Certificate of Appropriateness

Property 2625 N. LAKE DR. North Point North Historic District
Description of work We are removing the old three layers of roofing and installing a new architectural dimensional shingle to match up to the existing roof as close as possible. All vents will be installed on the back of the house so as not to be visible from the street. All flashings installed on both chimneys will be done in copper and in a historic step counter flashing. The existing copper gutters on the house will be tuned up, but saved at this point.

Date issued 9/18/2017 PTS ID 114390 COA: roof and chimney

Front of house

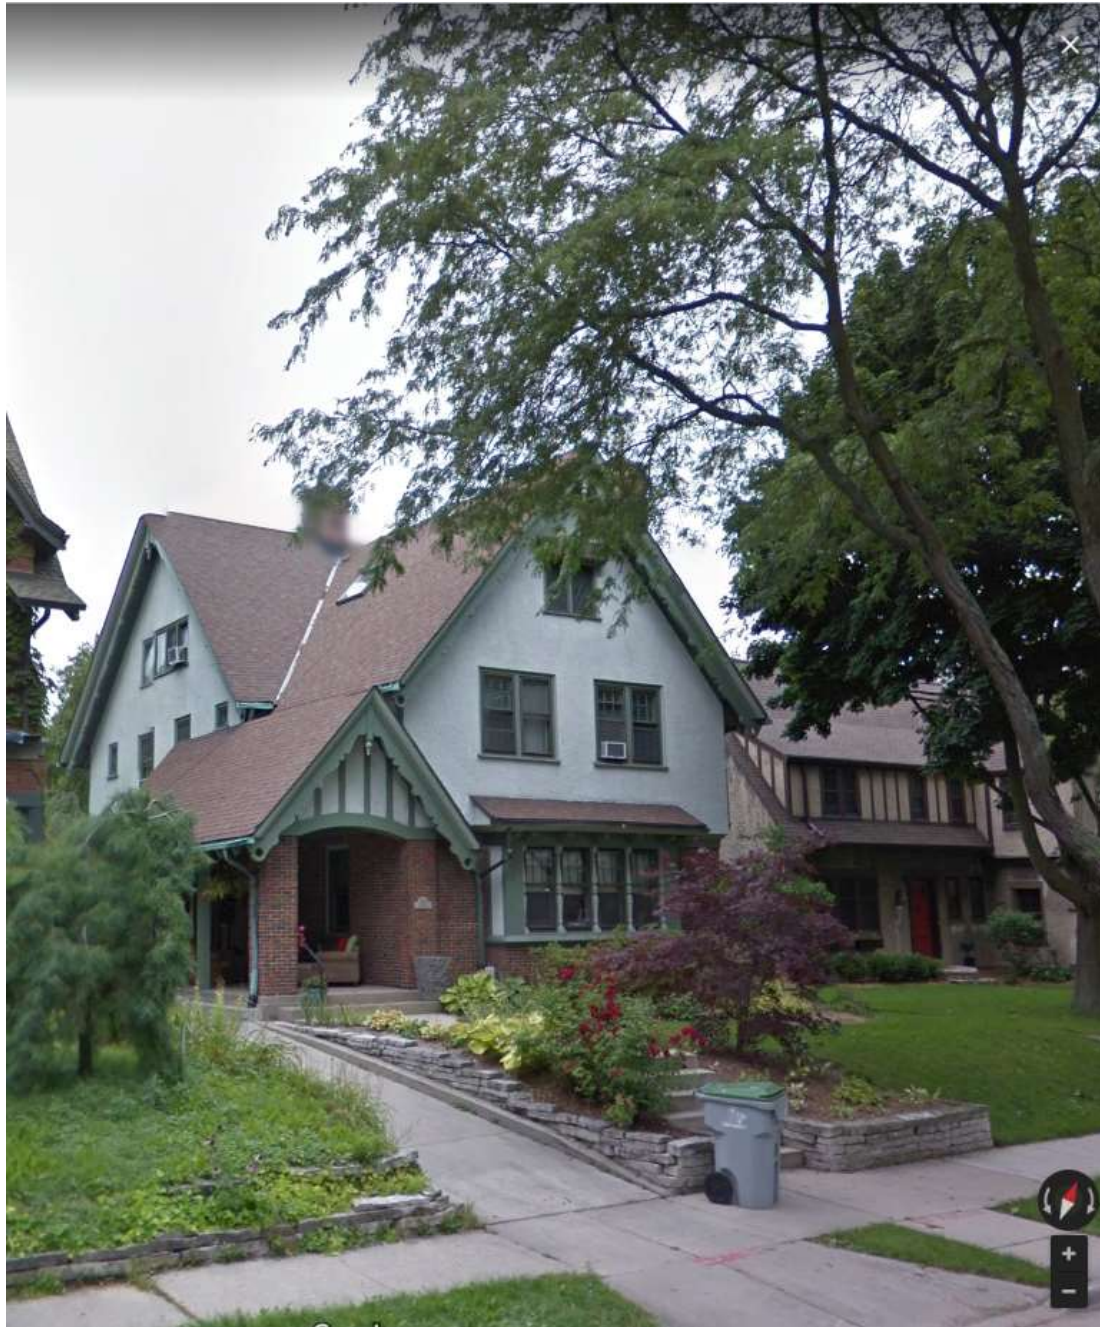
No dormers, chimneys, moldings or other permanent features will be altered or removed. No box vents, if used, will be visible from the street. If they are installed they must be on a rear slope not visible from the street and they must be painted to blend with the color of the roofing material. A continuous ridge vent can be installed in place of box vents, but the vent must extend across the entire ridge and not stop short. Built-in rain gutters will be retained and sealed where needed. Valleys must be metal W-shape with no interweaving of shingles. Valleys and flashing must be painted or factory-finished to match the roofing color, unless copper.

3.When installing new flashing at the masonry chimney, the flashing must be stepped or cut into the mortar joints. The bricks may not be cut to install flashing at an angle.

4.The partially rebuilt chimney must be rebuilt to exactly match the historic including bonding pattern, corbeling, and other details. Accurate measurements shall be taken prior to disassembling so the new chimney exactly matches the historic without alteration. Up close photos of the completed chimney must be provided with the final certification that when compared to the pre-project photos exactly match in all dimensions or the overall project will be denied.
